Work Order ID 58274

Item Name: Head Rest

DESIGN <i>[Signature]</i>	DRAWN BY <i>[Signature]</i>	DART AEROSPACE LTD HAWKESBURY, ONTARIO, CANADA	
CHECKED <i>PH</i>	APPROVED <i>[Signature]</i>	DRAWING NO. D3303	REV. B SHEET 1 OF 4
DATE 06.08.17		TITLE HEAD REST	SCALE 1:3
REV	DATE	DESCRIPTION	
A	04.08.18	NEW ISSUE	
B	06.08.17	UPDATED FLAT PATTERN TO FORM PART IN ONE OPERATION USING OFFSET DIE

DRAWING NO. D3303	TITLE HEAD REST	REV. B	DART AEROSPACE LTD ENGINEERING ORDER		D.E.O. NO. D3303-B-1	SHEET NO. SHEET 1 OF 1	SCALE NTS
DRAWN AJS	CHECKED <i>h</i>	MFG. APPR. <i>h</i>	APPROVED <i>h</i>		DE APPR. <i>h</i>		
DATE 08.10.15	DATE <i>08.10.15</i>	DATE <i>08/10/16</i>	DATE <i>08/10/16</i>		DATE <i>08/10/16</i>

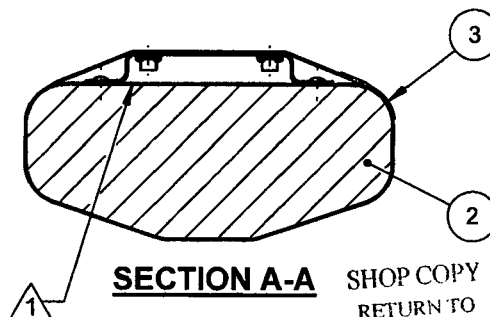
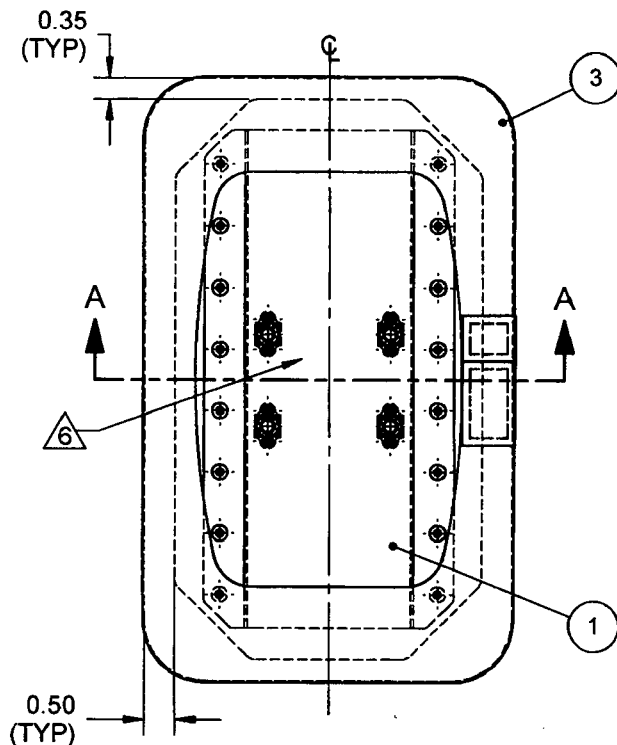
SHEET 1 ADD 1300L ADHESIVE BY 3M TO NOTE 1 AS FOLLOWS:

WAS:

- 1) BOND D3305-1 FOAM TO D3303-043 BRACKET ASSEMBLY USING 3M 1300 ADHESIVE (0.002" TO 0.010" THICK) IN ACCORDANCE WITH MANUFACTURER'S INSTRUCTIONS

IS:

- 1) BOND D3305-1 FOAM TO D3303-043 BRACKET ASSEMBLY USING 3M 1300 OR 1300L ADHESIVE (0.002" TO 0.010" THICK) IN ACCORDANCE WITH MANUFACTURER'S INSTRUCTIONS
